NOTE TO: FILE
FROM: Harold Lefevre, NMSS/DWM/URB
SUBJECT: REVIEW OF 1995 AND 1996 PRE-LICENSING INSPECTION REPORTS FOR MEXICAN
HAT, UTAH UMTRA SITE

Evaluation of HAT/MON LTSP dated June 11, 1997 for water resource protection

FIGURE 4.2
SEEP LOCATIONS AT THE MEXICAN HAT, UTAH, DISPOSAL SITE

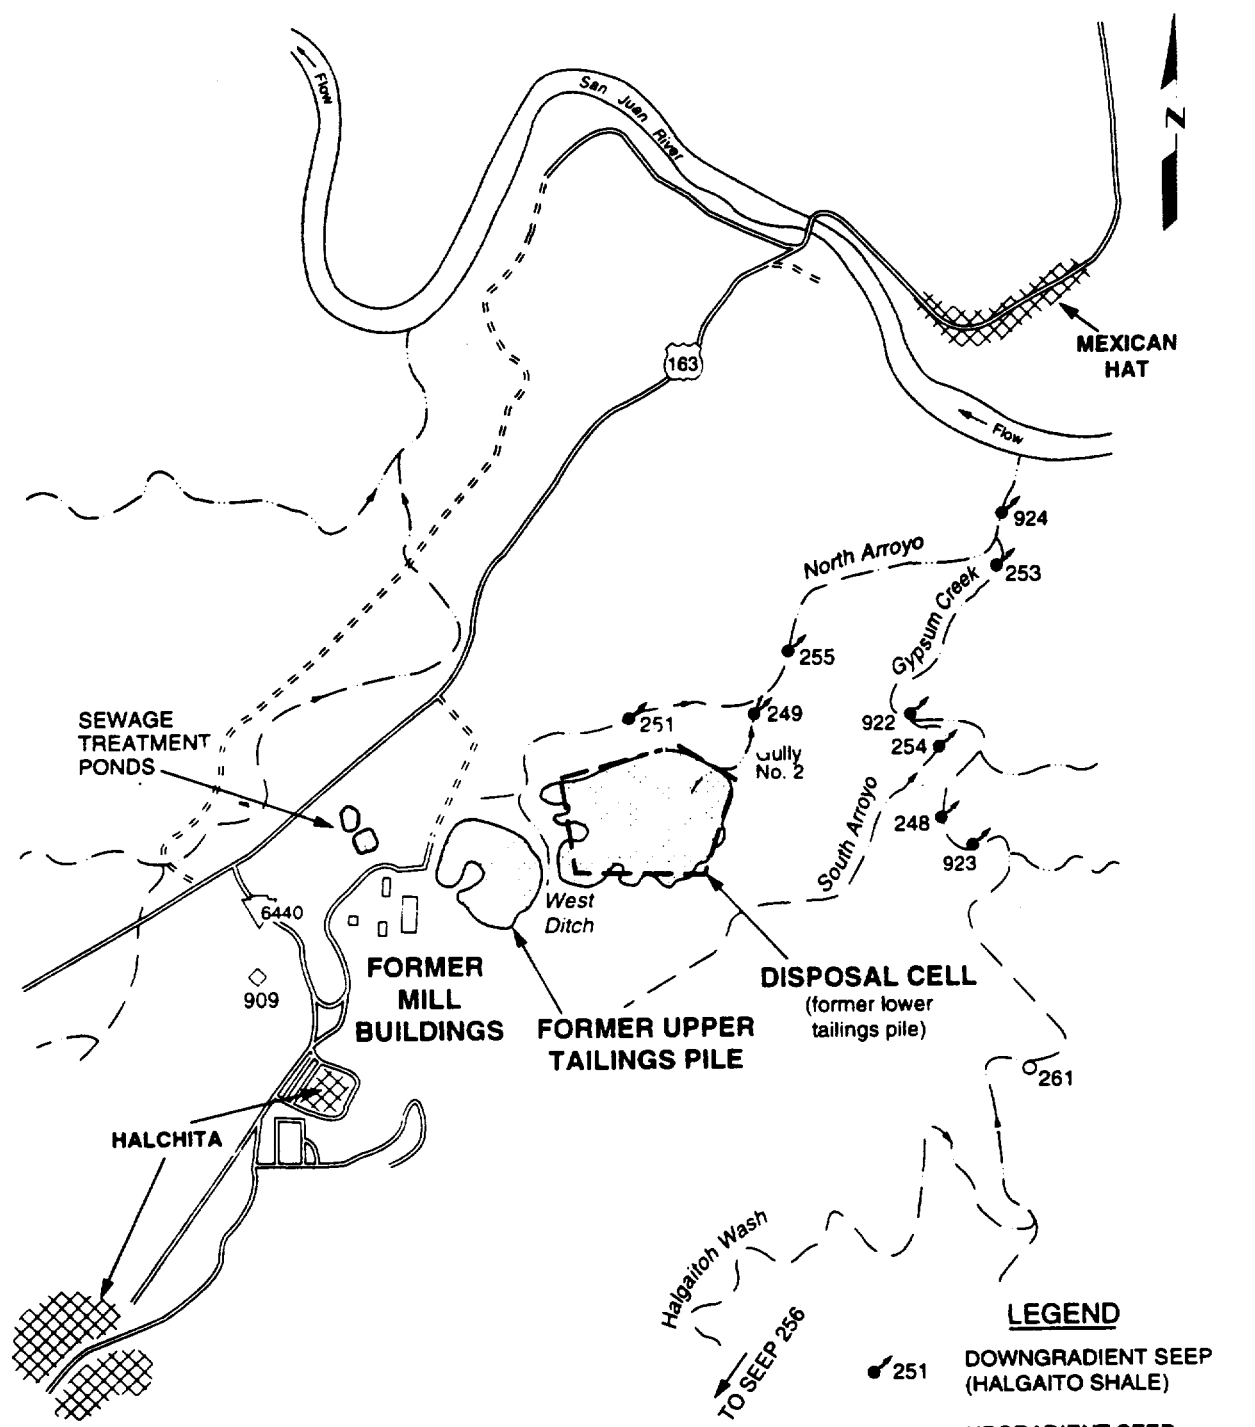
DOE proposes to monitor two seeps (251 and 249) in the North Arroyo; three seeps (248, 254, and 299) in Gypsum Wash; and one seep (261) designated as background in Gypsum Wash during annual inspections. DOE's proposed monitoring will entail visual inspections of the seepage, documenting seepage with photographs, and estimating seepage flow. Chemical analysis of seepage water will not be performed unless a significant increase in the seepage rate is observed. If water sampling is performed the seepage will be analyzed for ammonium, calcium, chloride, molybdenum, nitrate, potassium, radium-226 and radium-228, sodium, sulfate, total dissolved solids, uranium, and vanadium.

The primary reliance on seepage flow volume as a determinant of cell performance does not provide an adequate means of evaluating potential failure impacts that could develop over time. In addition, the lack of routine sampling and analysis of the seepage does not allow timely detection of seepage changes that may affect grazing animals or humans. This is also inconsistent with DOE's seepage monitoring commitments in the RAP.

DOE should, at a minimum, propose monitoring program that includes sampling and analysis of a limited number of indicator parameters in addition to the flow volume estimates. If analysis of the indicator parameters indicates a degradation of seepage water quality, then additional sampling of the full suite of constituents listed in the LTSP should be performed and an evaluation of whether degradation is the result of disposal cell failure. If the seep conditions change to the point of no flow, as is expected for some seeps, then the monitoring provisions of the LTSP can be amended to reflect those changes.
